CUPER heat recovery unit design has been modified

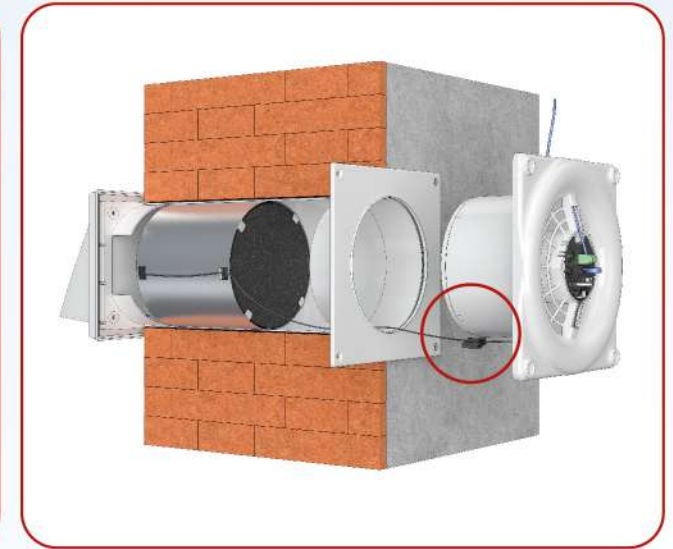
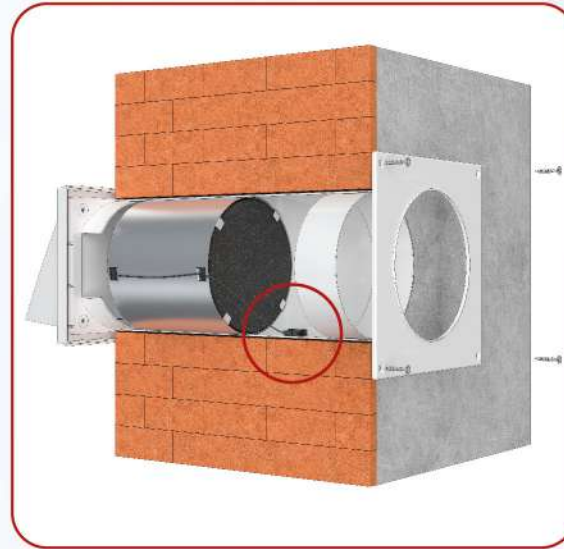
Temperature sensors were previously located on a loop and hooked up to a control board through the plug.

Now this sensor is a part of the board. Location like this doesn't make assembly harder and makes its mounting easier. Hooking up became simpler because you don't have to connect the enclosure to the sensor loop. An algorithm of operation in smart mode unchanged.
